DCE MEMORANDUM NO. 05-08

ROADWAY DESIGN BULLETIN 08-05

**Subject:** Project Information Sign

REVISIONS					
DATE	BY	DESCRIPTION	DATE	BY	DESCRIPTION
11/07/07	L.W.	New sheet Index 600 13 Of 13 PROJECT INFORMATION SIGN.

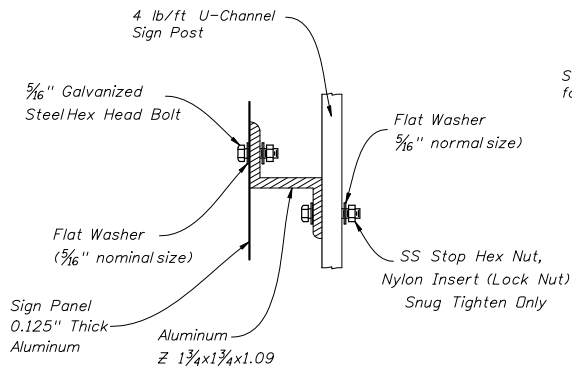
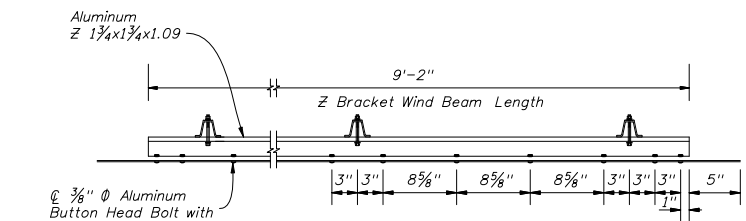
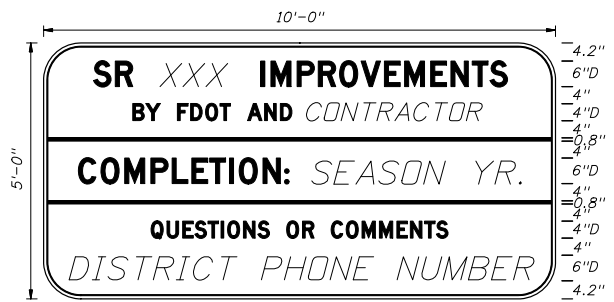
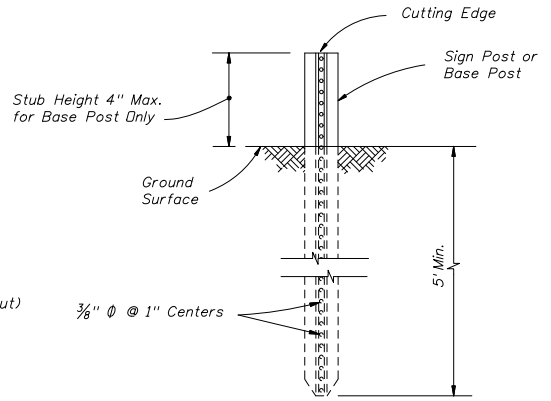
**RECOMMENDATION:** Starting with the October 2008 letting, the Project Information Sign shown in Interim Index 600 sheet 13 of 13 (attached) is required for all contracts with more than 90 days of contract time. This project specific sign shall be detailed in the plans, with the exceptions of "Season/Year" and "Contractor's name" and paid for under Maintenance of Traffic, Lump Sum, in accordance with specification 102-11.5.

Placement of these signs should be approximately 500 feet in advance of the first advance warning sign or as close to be beginning of the project as practical, on each mainline approach. This sign may be omitted if physical constraints prohibit placement of this sign due to its width.

**District Design:** Update plans to include a sign detail for the Project Information Sign beginning with the October 2008 letting, sooner if possible.

**10.7.3 Project Information Sign:** The Project Information Sign shown in Index 600 is required for all contracts with more than 90 days of contract time. This sign should be located approximately 500 feet in advance of the first advance warning sign or as close to be beginning of the project as practical, on each mainline approach. This sign may be omitted if physical constraints prohibit placement of this sign due to its width.
